# Review of Application by TowerNorth Development for a Cell Tower at 75 Eastern Avenue, Essex Massachusetts

June 8, 2021

Figure 1 - C-Squared Systems Attachment A - Existing coverage without proposed coverage

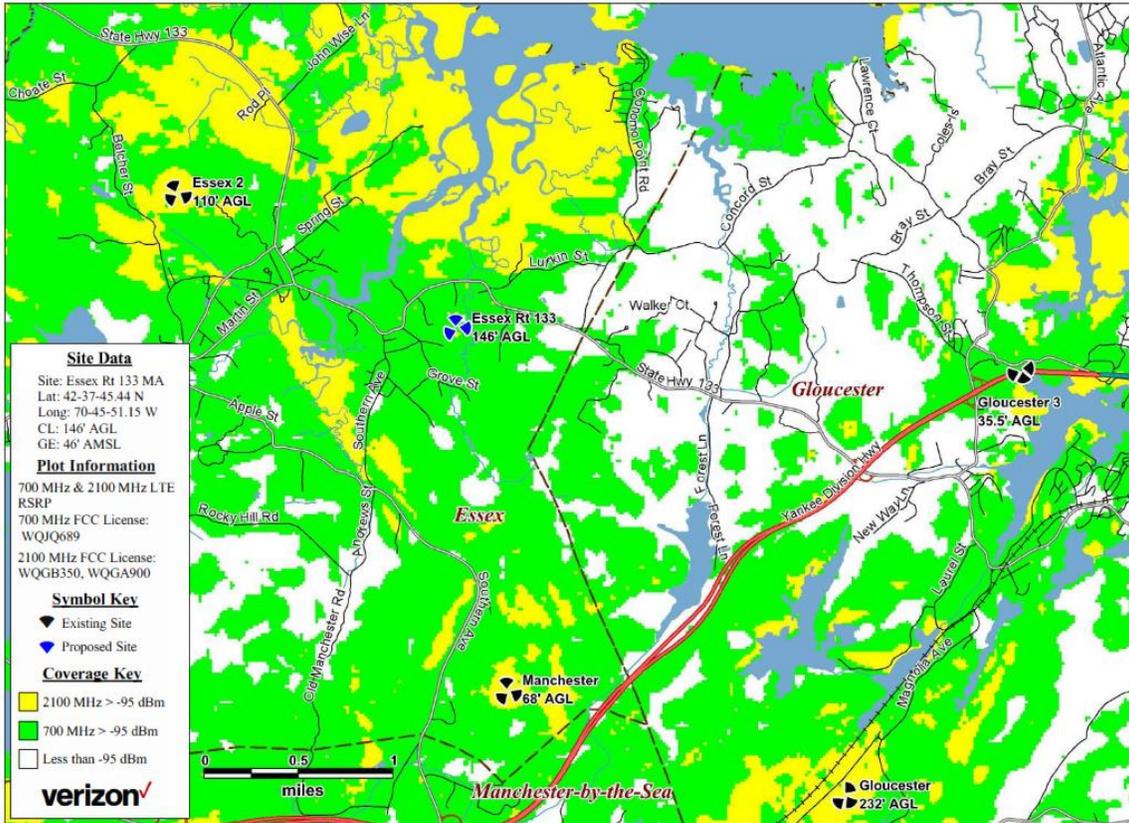
There is no coverage issue in the classic sense. Even relying on coverage modeled at the very conservative threshold of -95 dBm, C-Squared Attachment A reveals there is substantial coverage in the area of Essex surrounding the proposed facility site. For quick reference, selected attachments from the C-Squared report are shown below. The full-size versions are in the C-Squared report.

Figure 1 very clearly demonstrates Verizon’s desired level of coverage exists in nearly the entire area between the existing Essex 2 site and the Gloucester line.<sup>17</sup> This is at the aspirational signal level of -95 dBm.

Figure 2 - C-Squared Systems Attachment C - Existing coverage without proposed, based on unspecified lesser threshold

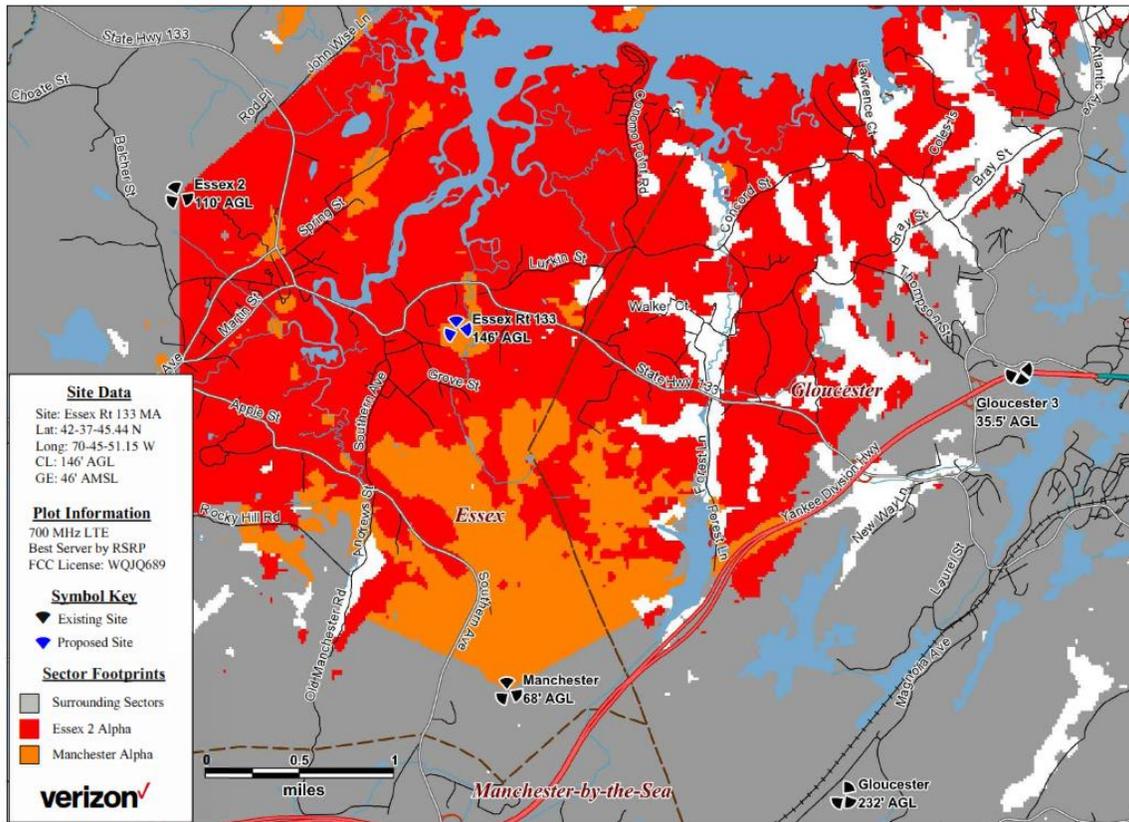
Figure 2 shows how Essex 2 coverage goes outside of Essex well into Gloucester when the lesser signal level more consistent with voice calling reliability is used.

C-Squared is implying (and asking the Board to infer) from the red area of Figure 2, that Essex 2 southeast sector (“Essex 2 SE”) is under a capacity crunch. This is based on the two factors obtained from the maps. One factor is the implication that this is a relatively large area of streets and associated development in both Essex and Gloucester that is too large for Essex 2 SE to have the capacity to serve. The other factor is the implication that a large proportion of the red area is below -95 dBm (mostly in Gloucester), which could further draw down the capacity of Essex 2

with many cell-edge subscribers. However, the application provides no metrics for the number of subscribers likely to be accessing Essex 2 SE or any targets for how many are too many. No data on the actual capacity loading on Essex 2 SE is provided.

The Board is able to decide whether to accept the applicant's expectation that the Board will infer the need for a capacity solution from the maps or whether to seek additional corroborating data for the record.

Figure 3 - C-Squared Systems Attachment D - Sector footprints with proposed facility (arrows mark limited effectiveness of existing red sector)

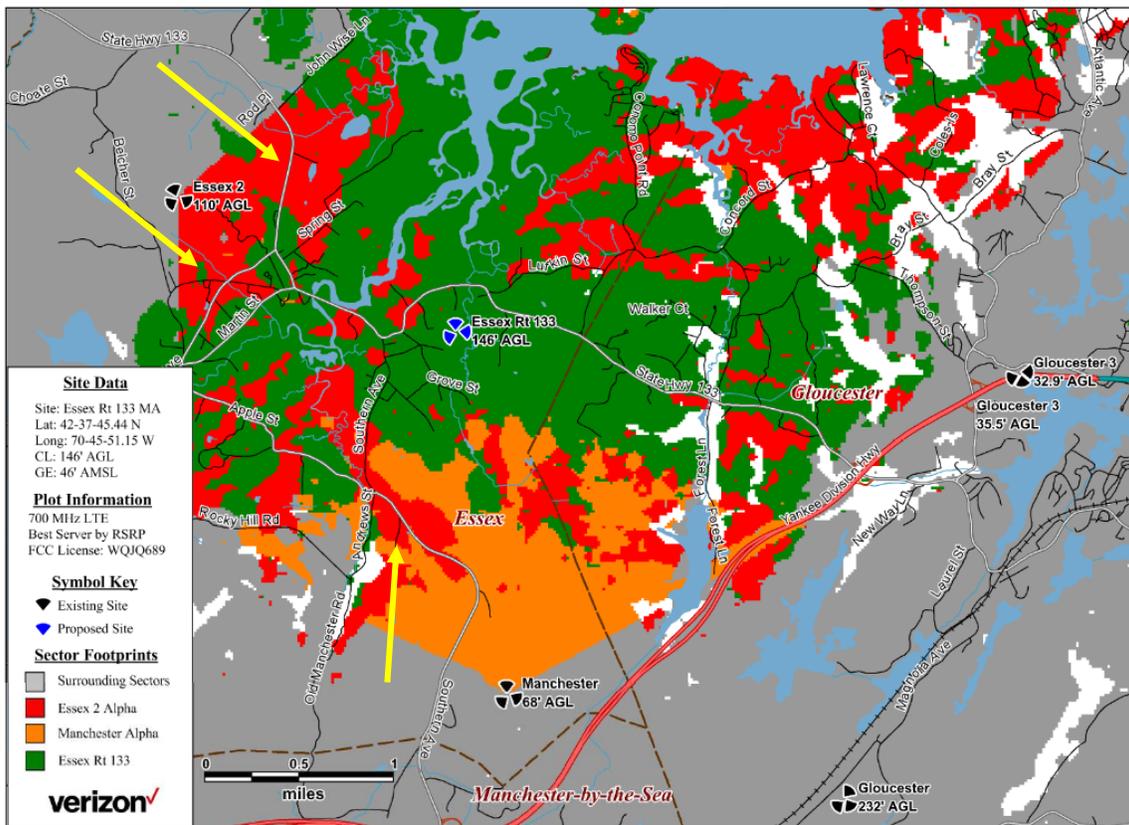
If capacity needs were demonstrated to the Board’s satisfaction, the Sector Footprint of the proposed facility is most instructive on the service gains in and around Essex. Figure 3 shows the proposed facility almost eliminating the need for the Essex 2 southeast sector. In a word, Essex 2 SE is almost *eclipsed* by the addition of the proposed facility. In this way, Essex 2 SE is reduced to a minor role not providing much capacity to Essex, as seen by merely serving half-mile segments of Western Avenue and westerly Rt 133 and a mile segment of Southern Avenue (yellow arrows annotating Figure 3), plus a few smaller pockets. By nearly eliminating the usefulness of Essex 2 SE, the proposed three-sector tower would only triple the 700 MHz capacity to the area, instead of quadrupling it. Placing the proposed facility more to the west would give Essex 2 SE a larger share of Essex to serve, thereby increasing the overall network efficiency of the new site.

Figure 4 - C-Squared Systems Attachment B - proposed coverage at -95 dBm

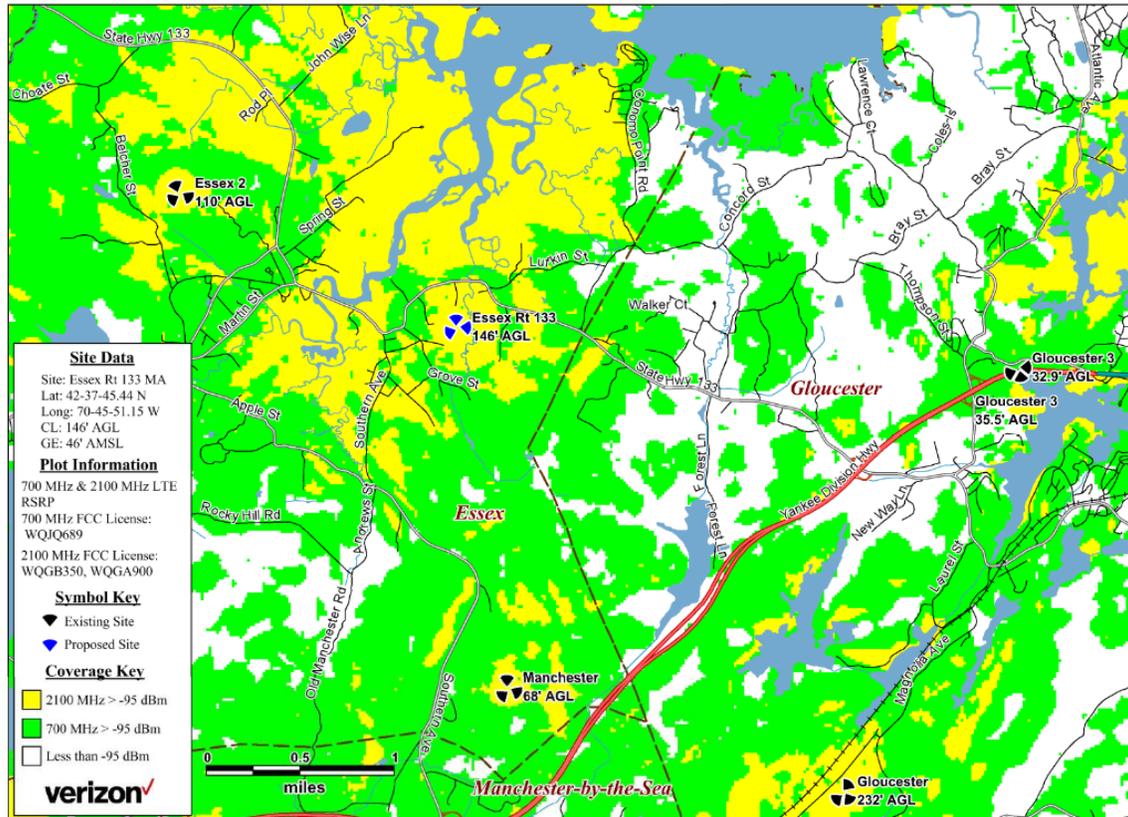
At 2100 MHz, the gains from the proposed tower shown in Figure 4 seem impressive on first glance (much more yellow on Attachment B than on Attachment A). On closer inspection, vast areas of salt marsh and estuary are the recipients of the expanded 2100 MHz service. In developed areas, except for the coverage gain in the marina area on the waterfront by Rt 133, only about a ¼ mile radius from the proposed site obtains -95 dBm or better signal from the proposed site at 2100 MHz.

Figure 5 - Aerial photo markup of example alternatives (yellow curves are 2 miles from existing towers)

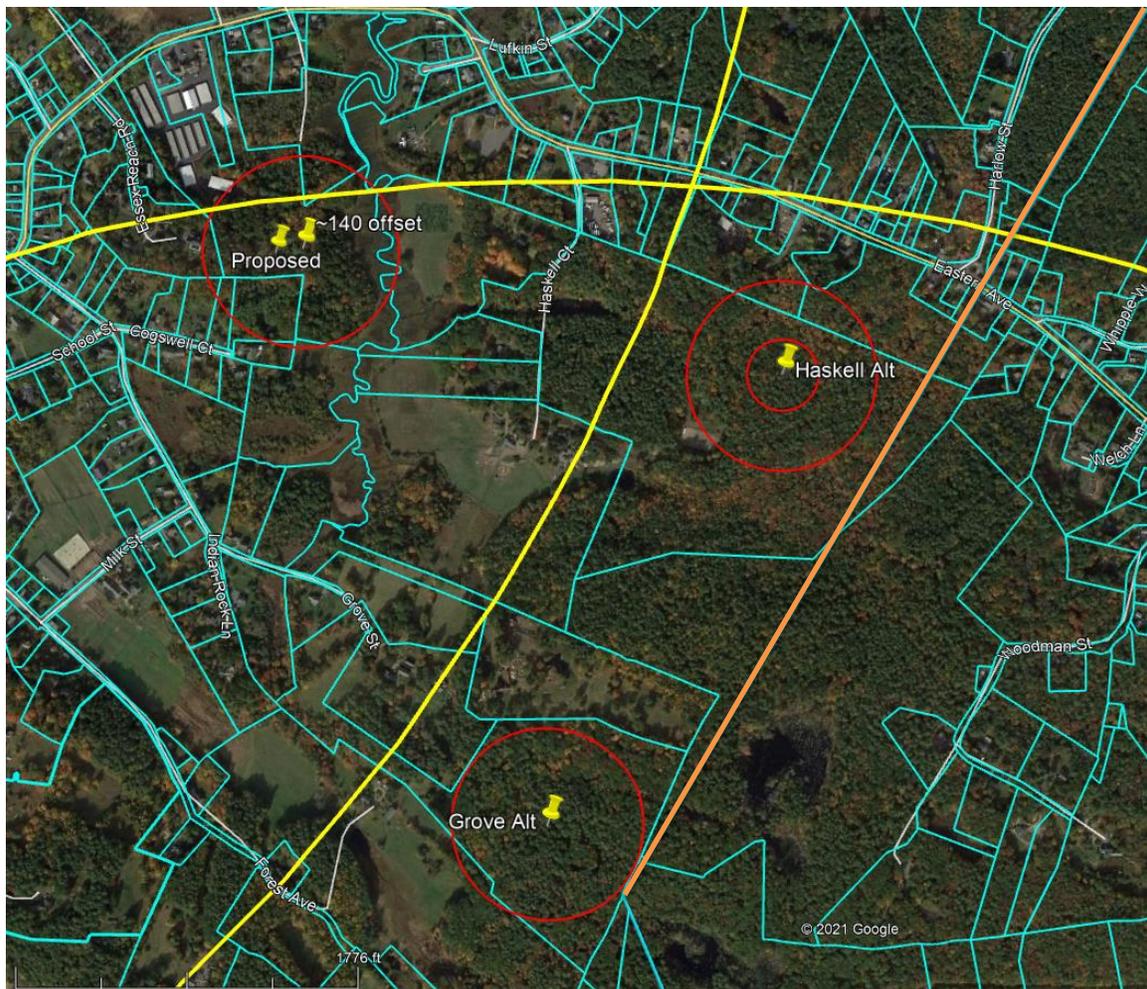
Below, Figure 5 is an aerial photo from Google Earth, overlaid with property boundaries and some additional markings. The two yellow rings are the 2-mile radiuses from the nearest towers. The orange line is the Gloucester border.

The proposed tower site is the left of two push-pins at the proposed parcel, upper left. Other sites are selected for illustration. Large red circles are 500-foot residential radiuses. One small circle is a 187.5-foot property line setback for a 150-foot tower.

The second alternative example relocates the tower to a position about 140± feet easterly of the proposed position (pushpin “140 offset”).

Based on the applicant’s site plans, this location can satisfy the 150-foot wetland setback for towers. It might require non-tower construction within the 150-foot buffer, or asymmetrically

The third alternative example is on a large parcel off Haskell Street, #137-24. There seems to be plenty of space to avoid mapped wetlands, meet the property line setback and the 500-foot residence setback. This location is within only one 2-mile tower radius.

The fourth alternative example is on a large parcel off Grove Street, #139-6. There seems to be plenty of space to avoid mapped wetlands, meet the property line setback and the 500-foot residence setback. This location is within only one 2-mile tower radius.
